**BEFORE THE INDEPENDENT HEARING PANEL  
FOR THE QUEENSTOWN LAKES PROPOSED DISTRICT PLAN**

**In the matter** of the Urban Intensification Variation to the proposed  
Queenstown Lakes District Plan

**SECTION 42A REPORT OF CORINNE FRISCHKNECHT  
ON BEHALF OF QUEENSTOWN LAKES DISTRICT COUNCIL**

**6 June 2025**

*Figure 2: location of 182D Arthurs Point Road*

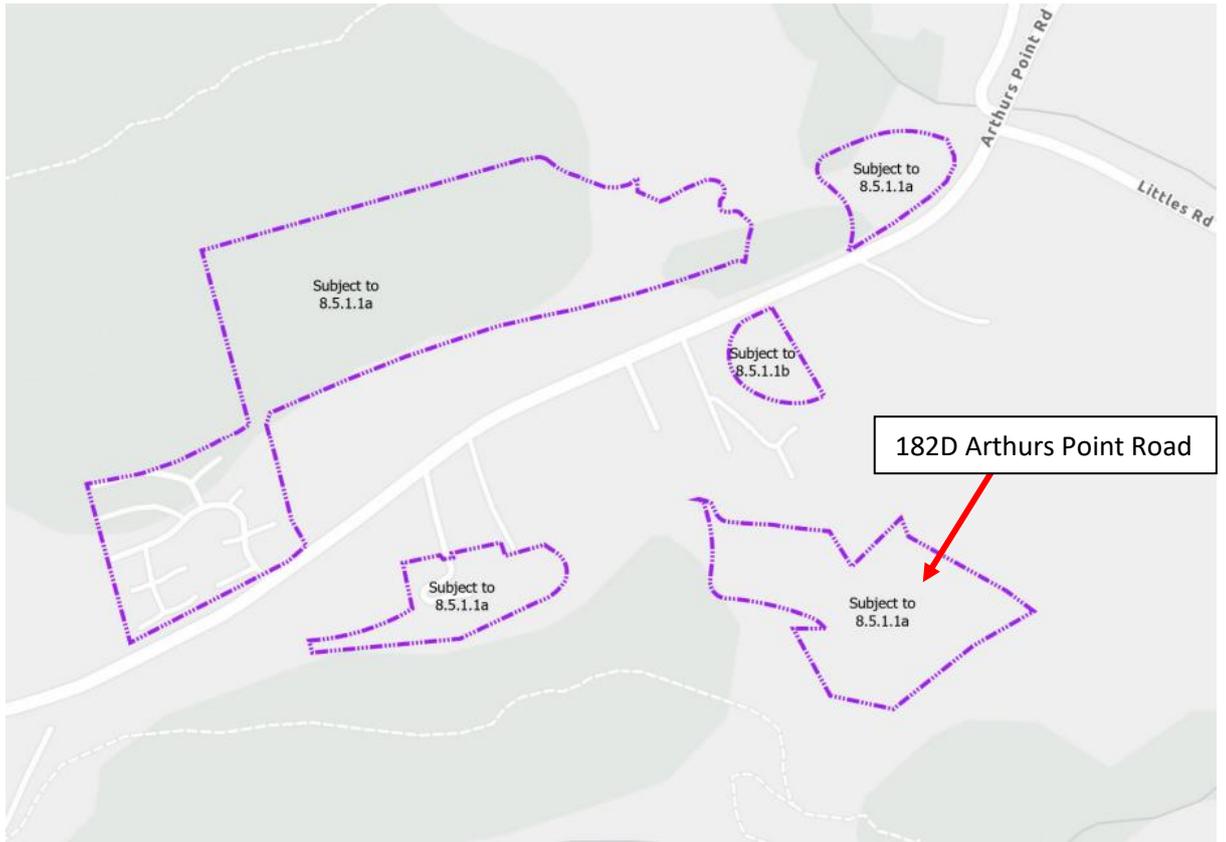
**4.118** The site that Arthurs Point Trustees Limited (1260.5) refers to in their submission is shown below. Notified Rule 8.5.1.1(a) restricts the maximum building height to 8m in this location.

**4.121** Whilst I acknowledge that building heights have been exceeded in portions of the Arthurs Point Trustees Limited site, I do not think it is appropriate to remove this site from being subject to notified Rule 8.5.5.1a as this would provide a blanket height for the entire site without the opportunity for consideration of design that is provided for by notified Rule 8.5.1. I consider that an assessment as to whether greater heights at this location is appropriate should continue to be assessed on its merits through a resource consent process to ensure that it is appropriate given its location near an ONL.

Figure 3: RM191333 approved site plan

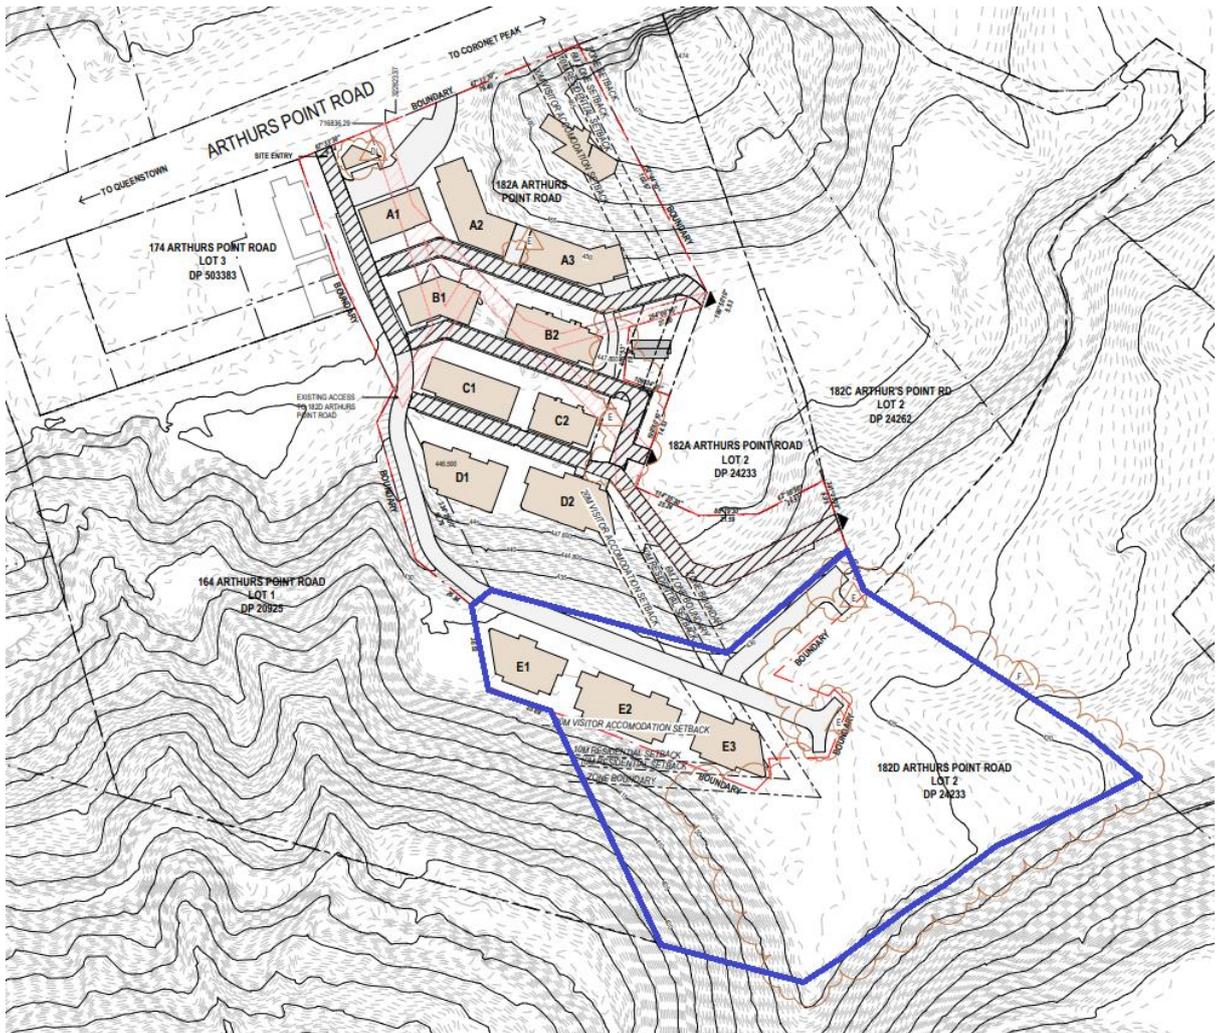
- 4.119** The submitter notes that apartment buildings previously approved under RM191333 within the area subject to notified Rule 8.5.1.1a are 12m-plus high so have already breached the 8m height limit and were considered appropriate to do so from a landscape perspective. As part of this consent, a detailed planting plan was required to ensure the integration of the proposed development into the Arthurs Point context and to mitigate any adverse effects.
- 4.120** As shown in Figure 3 below, the buildings within 182D Arthurs Point Road are located in the northern part of the site and away from the adjoining ONL - Kimitiākau (Shotover River). Furthermore, the consent specified the design materials used and a condition that the final renders and external material at building consent stage required Council review and acceptance.

*Figure 4: location of sites referred to in submission 198*

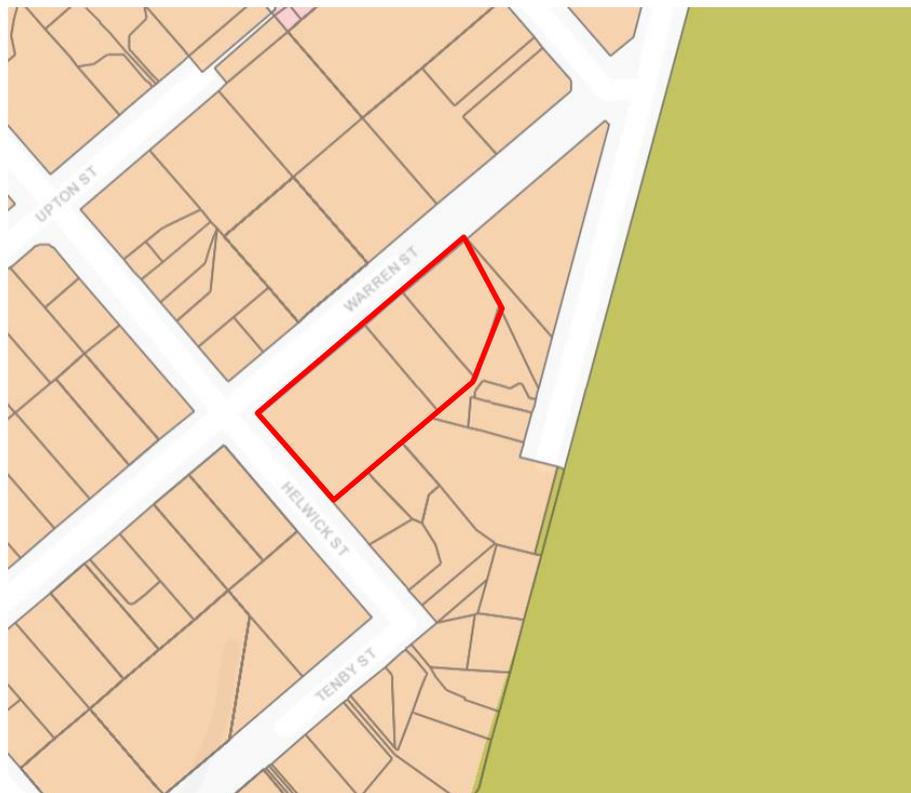
- 4.133** In their submission J O'Shea, H Russell, J Russell and M Stiasny (198.5) note that issues have arisen in relation to the groundwater table under and in the vicinity of the Warren Street Properties. The location of the properties as identified in the submission point are located on the eastern periphery of the Wānaka Town Centre and shown in the map below:

- 4.134** The submitter has provided a number of examples of recent development in close proximity to the Warren Street Properties that they say has been documented in RMA proceedings by Otago Regional Council (**ORC**), QLDC and the Environment Court, to have contributed to issues in relation to the groundwater table, including Belvedere Apartments, and an appeal *Kreft v Queenstown Lakes District Council* which include reference to the Aquifers as a special circumstance in which notification for an application for resource consent involving earthworks was to be required.

- 4.136** The appropriateness of intensification in this area has been addressed by Ms Morgan in Section 14 of her evidence and I agree with her assessment. The management of groundwater and effects of development on the Wānaka Basin Cardrona Gravel Aquifer is a matter for the Otago Regional Council (**ORC**) to regulate through its Regional Plan. Noting that ORC has not made a submission on the UIV raising concerns with development in Wānaka.
